SERVICE BULLETIN

SUBJECT: HORIZONTAL STABILISER - IMPROVED DURABILITY (MODIFICATION N407B)

This Service Bulletin introduces modification N407B to improve the in service durability of the horizontal stabiliser.

FIGURE 1

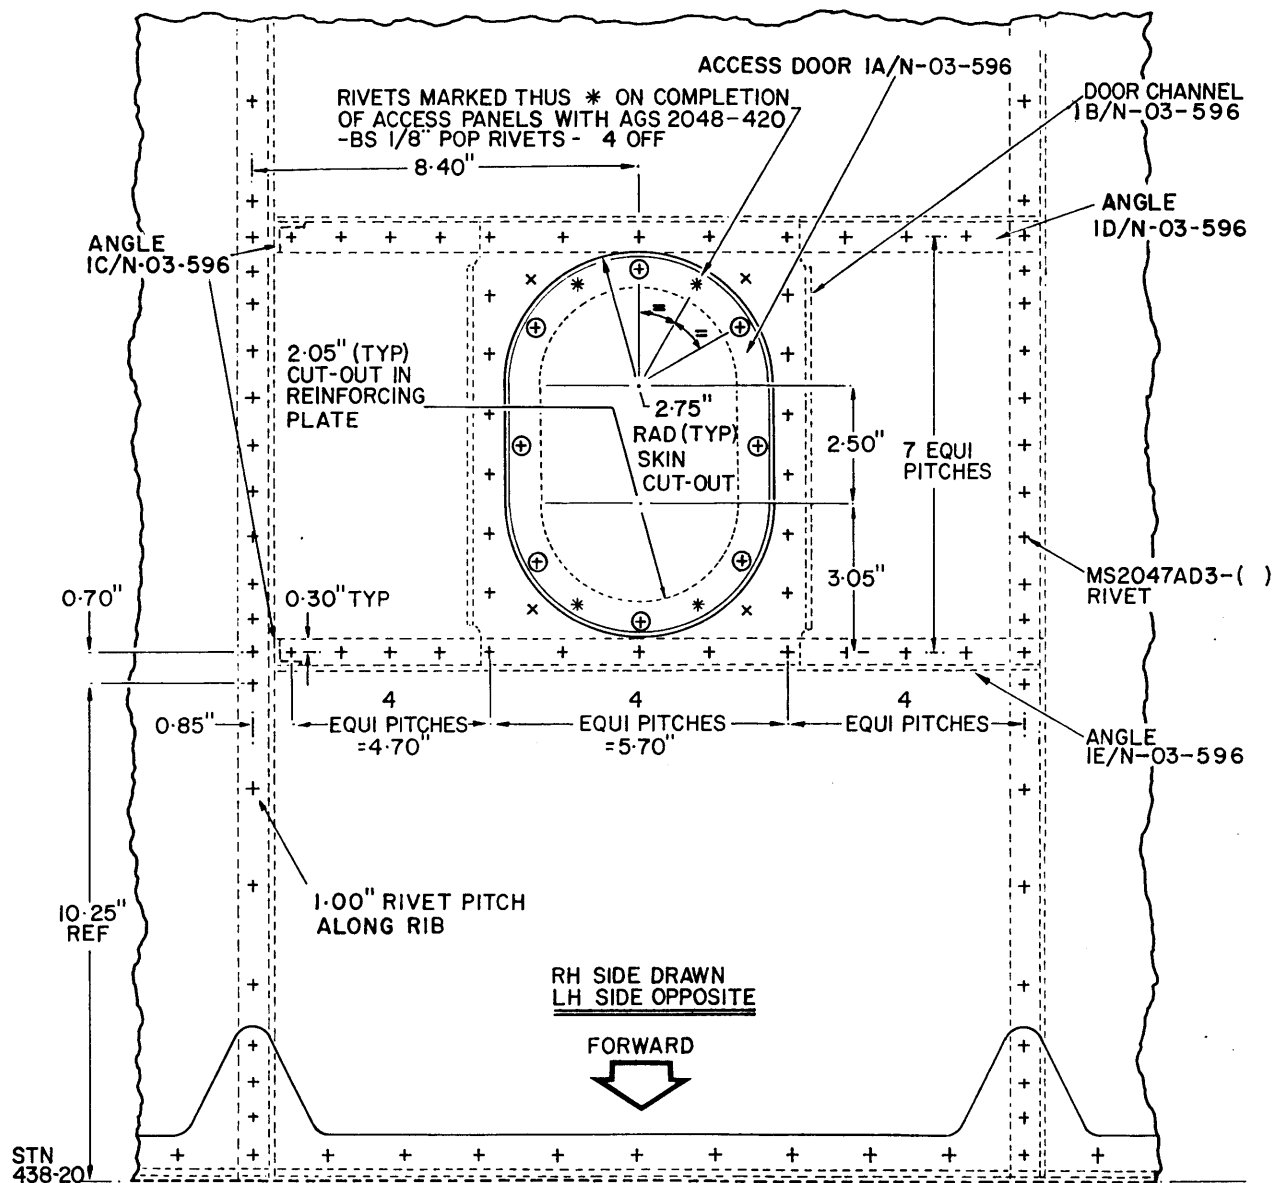
- A. (1) Remove the Horizontal Stabiliser as described in MM 55-20-00.
- (2) Install the six access panels in the tailplane top skin as shown in figure 1 and figure 2.
- (3) On the inboard rib fit, as shown in figure 2 Detail C, the reinforcing doubler plate 1C/N-03-599 to the diaphragm 1S/N-30-121 and 1R/N-30-121.
- (4) On the rear spar inboard end extend the trim tab actuating rod cut out as shown in figure 2 Detail A.
- (5) Add an additional diaphragm and angle at stn 468.89 Ref Figure 2 Detail B.
- (6) Obtaining access through the access panels, inter pitch (with 3/32 inch rivets P/N MS20470AD-3 length to suit) existing rivet pitch along skin to rib joint.

- (8) On completion of the reworks described, clean out the internal structure of tailplane of all foreign bodies (e.g. swarf, rivet tails, etc.), and fit access panel doors using PR 1221 or 1222 compound, or equivalent, to seal doors. Secure doors using eight MS24693-S272 screws and four AGS 2048-420BS rivets as shown as figure 1.
- (9) Balance Horizontal Stabiliser in accordance with Table 1 of this Service Bulletin.

FIGURE 2

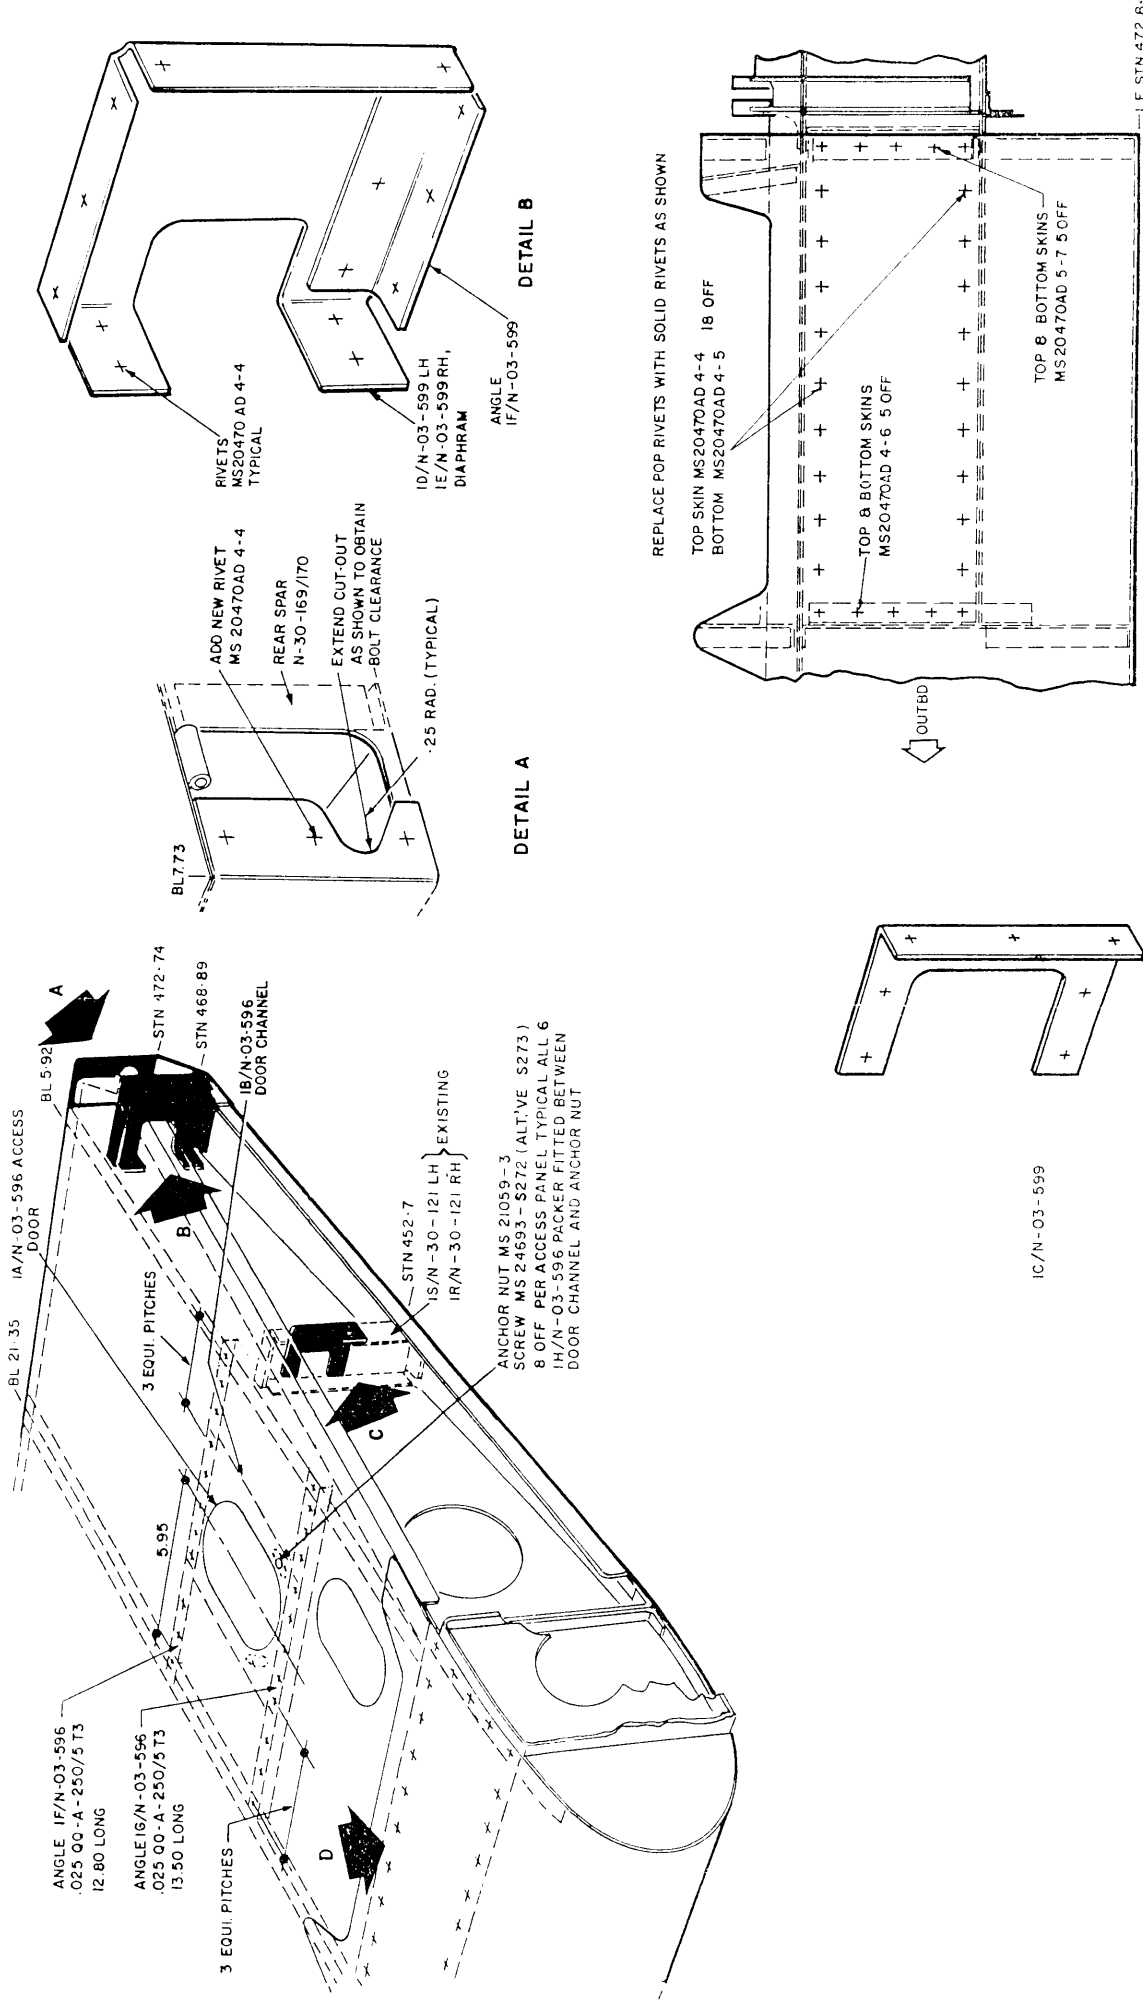
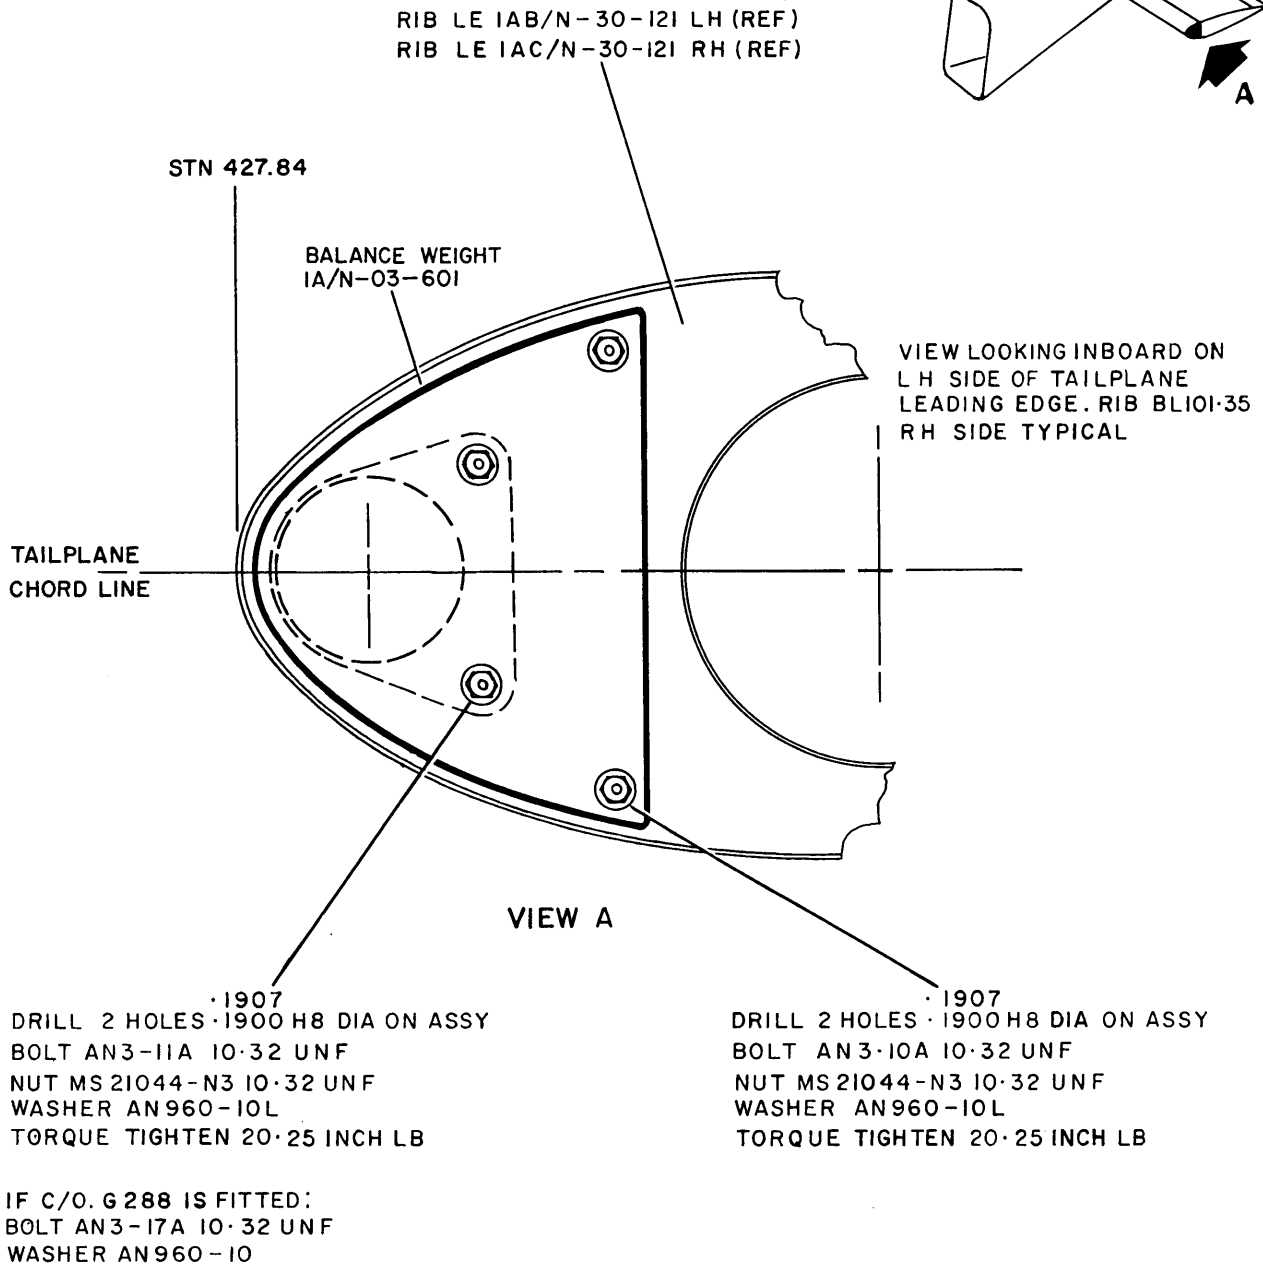
Replace existing AGS 2050 rivets in the leading edge panel (BL 5.92 to BL 21.95 RH and LH) as shown in figure 2 detail D.

All AGS 2050 rivets are to be replaced by solids or cherry rivets if desired.

FIGURE 3

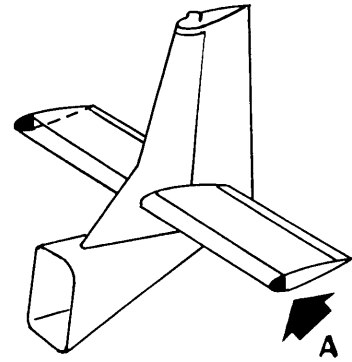
- (7) Remove the tip fairings and on the outboard rib (BL 101.35) fit the mass balance as shown in figure 3).

Replace tip fairing picking up existing rivet locations starting at the L.E. and working back towards the T/E. Oversize rivets may be used and interpitch if required.
